Access Compliance Report

Public Rights-of-Way

(Curb Ramps)

Intersection ID: 49929	Main Street: ASHBOURNE_HALL_RD	Cross Street: CHAMBERLIN_RD	Location: SW
ADA ID: F6AF836616AE	Ramp Type: BlendTrans1	Initial Pass/Fail: Fail	Overall Compliance: No
		Severity Score: 12.5

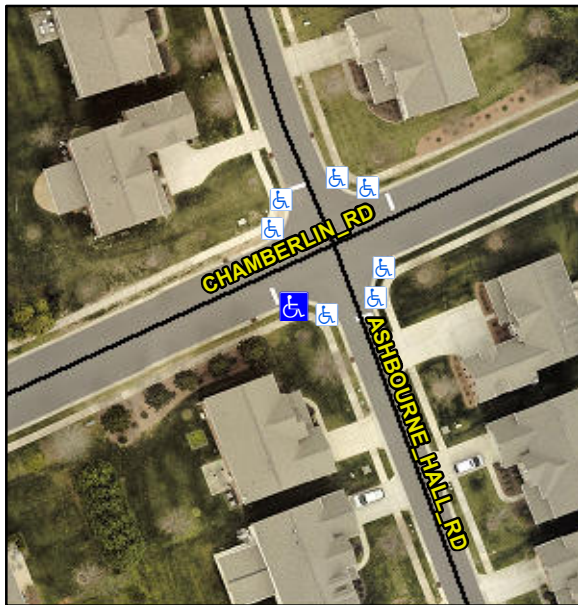
Not Found, R304.5.3

Compliance	Description	Data	Compliance	Description	Data
N/A	Ramp Length (in)	48.0	Yes	BlendTrans Slope (%)	2.1
Yes	Ramp Width (in)	48.0	No	BlendTrans XSlope (%)	6.7
N/A	Flare Type LT	N/A	N/A	Flare Type RT	N/A
N/A	Flare Slope LT (%)	N/A	N/A	Flare Slope RT (%)	N/A
N/A	Flare Traversable LT?	N/A	N/A	Flare Traversable RT?	N/A
N/A	Landing Length (in)	N/A	N/A	DWS Provided?	N/A
N/A	Landing Width (in)	N/A	N/A	DWS Contrast?	N/A
N/A	Landing Slope (%)	N/A	N/A	DWS Length (in)	N/A
N/A	Landing X Slope (%)	N/A	N/A	DWS Full Width?	N/A
N/A	Landing Curb? (Y/N)	N/A	N/A	DWS Offset (in)	N/A
N/A	Shared Landing?	N/A			
N/A	Gutter Ponding?	N/A	N/A	Gutter Slope (%)	N/A
N/A	Gutter Lip Ht (in)	N/A	N/A	Gutter X Slope (%)	N/A
N/A	Painted X Walk1?	No	N/A	Painted X Walk2?	N/A
	X Walk 1 Direction	To NW		X Walk 2 Direction	N/A
	X Walk 1 Width (in)	N/A		X Walk 2 Width (in)	N/A
	X Walk 1 Slope (%)	2.6		X Walk 2 Slope (%)	N/A
	X Walk 1 X Slope (%)	6.1		X Walk 2 X Slope (%)	N/A

N/A	Ramp inside XWalk1?	N/A	N/A	Ramp inside XWalk2?	N/A
	Road Slope (%)	6.1		Clear Space?	N/A
	Road X Slope (%)	2.6	N/A	Clear Space to XWalk (in)	N/A
N/A	Any Obstructions?	N/A	N/A	Storm Grate/Utility Hazard?	N/A
	Obstruction Type			Storm Grate/Utility Type	
		N/A			N/A
			Yes	Surface Condition? (G/P)	Good
			No	Curb Slope (%)	10.2

Remove & Replace Curb Ramp With Two New Directional Ramps or Equivalent.
